Water Service Provider Letter

AMENDED Service Provider Letter

Fox Hollow Residential Subdivision and Off-site Stormwater Facility

FIRE CODE / LAND USE / BUILDING REVIEW
APPLICATION

WETLAND AND BUFFER IMPACTS

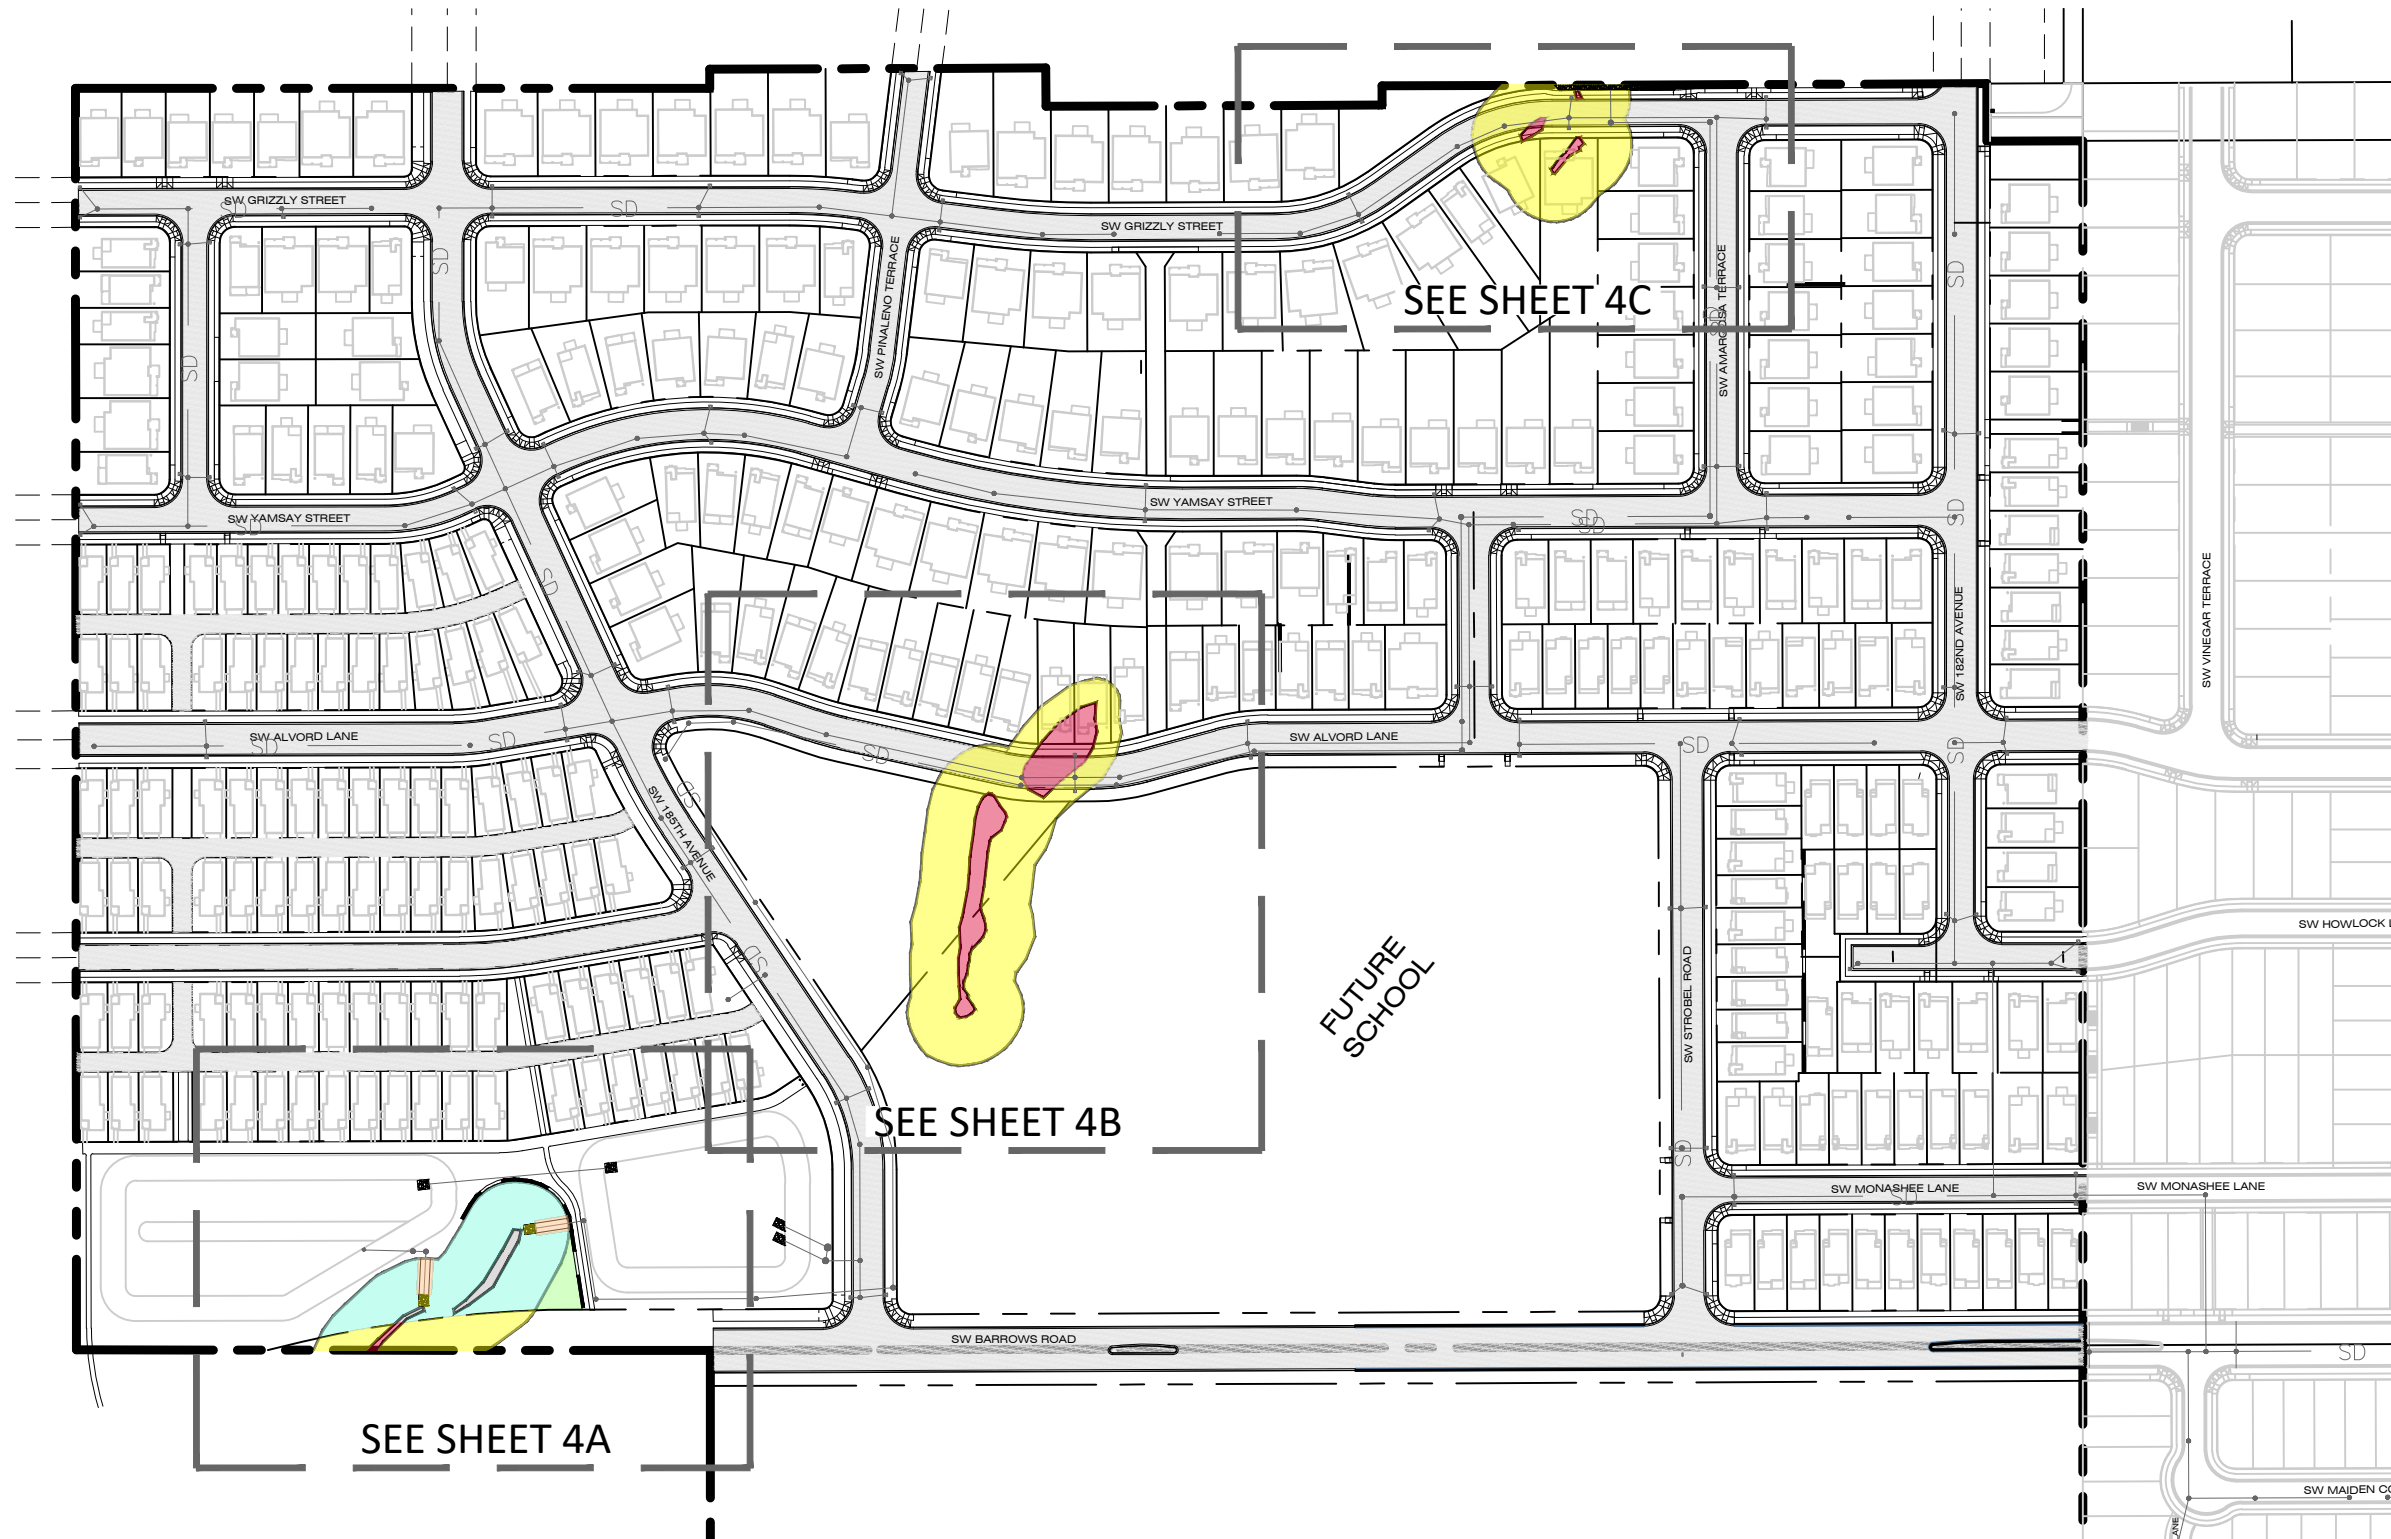
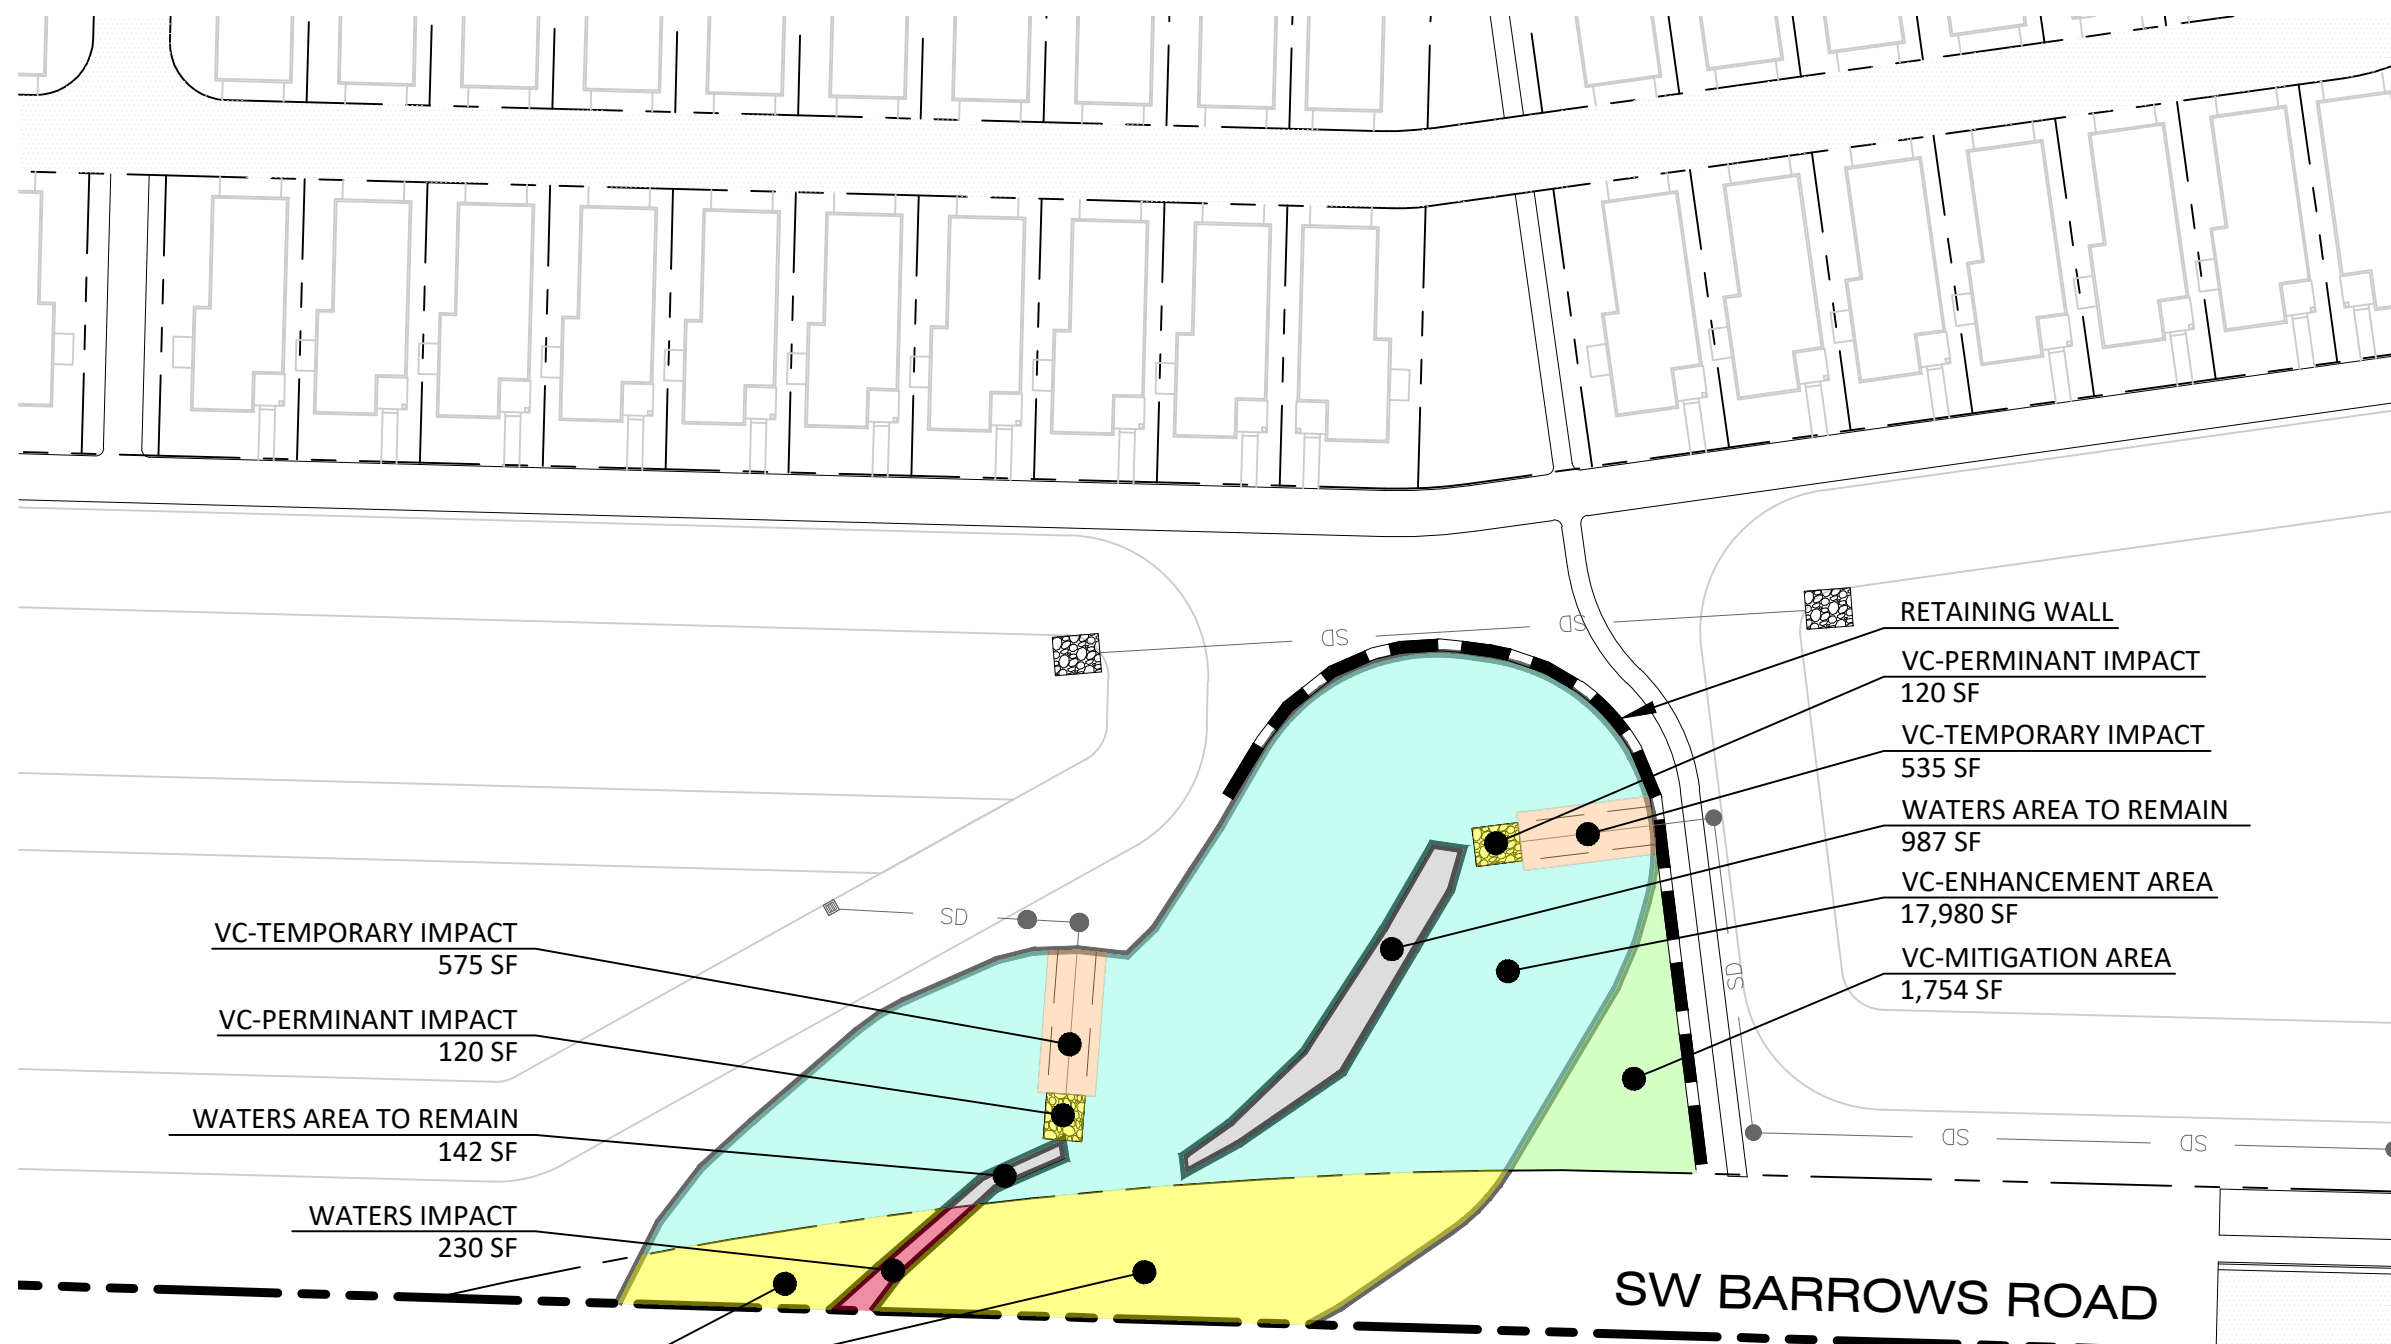
LEGEND		
AREA DESCRIPTION	AREA (SF)	PLANTINGS
WATERS AREA - EXISTING TO REMAIN	1,129	-
SENSITIVE AREA - PERMANENT IMPACT	9,061	-
VEGETATED CORRIDOR - ENHANCEMENT AREA	17,980	180 TREES, 899 SHRUBS
VEGETATED CORRIDOR - TEMPORARY IMPACT ENHANCEMENT AREA	1,110	11 TREES, 56 SHRUBS
VEGETATED CORRIDOR - PERMANENT IMPACT	63,341	-
VEGETATED CORRIDOR - MITIGATION AREA	1,754	18 TREES, 88 SHRUBS
OFFSITE MITIGATION AREA	8,825
